**ADDENDUM NO. 09 TO THE BID DOCUMENTS**

**Bid Number: 2020-17-81**  
**Utility Facility Improvements Project**  
**Addendum Date: August 6, 2020**

PROPOSED DETAIL:  
WOOD STUD WALL  
36"X80" INT DOOR  
Scale 1/4" = 1'

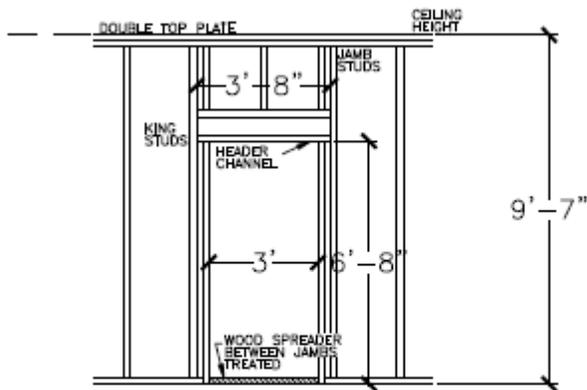
The last RFI's stated to reuse the ceiling grid by painting it after spraying the foam and then installing new ceiling tile. However, there will be a new wall installed in the main office area where the teller windows are located. The old grid will need to be removed to install the new wall. This will be a problem.

Please see sheet A3, wood frame wall goes to ceiling height and should not interfere with grid.
